DEVELOPMENT APPLICATION

APPLICATION NUMBER:	PLN-24-156
PROPOSED DEVELOPMENT:	Two lot subdivision
LOCATION:	5 Second Avenue West Moonah
APPLICANT:	S R Pulford
ADVERTISING START DATE:	24/07/2026
ADVERTISING EXPIRY DATE:	07/08/2026

JMG Engineers have been engaged on behalf of the developer to provide the design for stormwater surface drainage, including a proposed pump station and associated storage for each lot to collect and remove surface water from the proposed subdivision at 5 Second Avenue.

RFI RESPONSE
5 Second Avenue, West Moonah
PLN-24-156

Figure 1: Cross section of access for lot 2 at narrowest point (Source: extract from subdivision plans sheet 5 of 8)

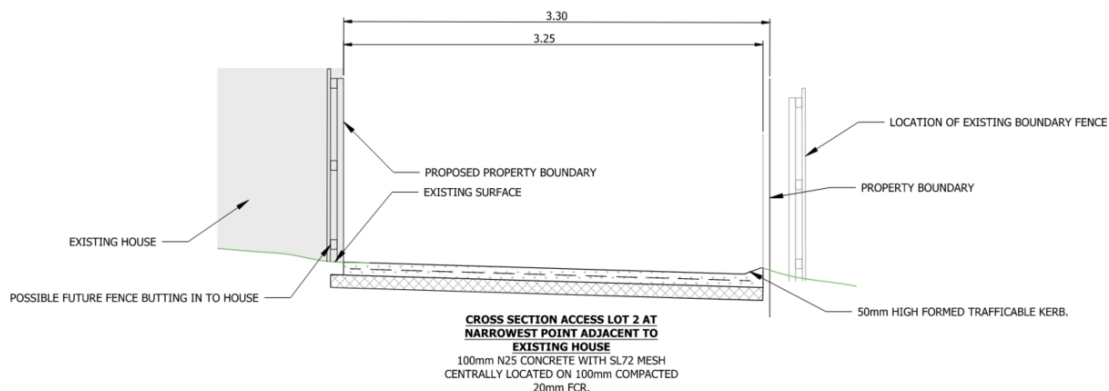
3. Please provide amended details of the driveway/access design onto each new lot in accordance with Local Government Standard drawings for subdivision LGAT drawing TSD-R09-v3 and Off-street parking Australian Standard AS2890.1:2004. The plan must demonstrate compliance to the standard; information including the driveway access slope, gradients, cross-section, long-section, spot levels, materials and drainage details are required.

AS2890.1 Clause 2.6.1 specifies the minimum width of a domestic driveway (vehicle path within a domestic property) is 3.0m

The clear width at the narrowest point on the internal driveway at the corner of the existing house is 3.3m, which satisfies AS2890.1.2004 and clause C2.6.2 A1.1(b) (See Figure 1).
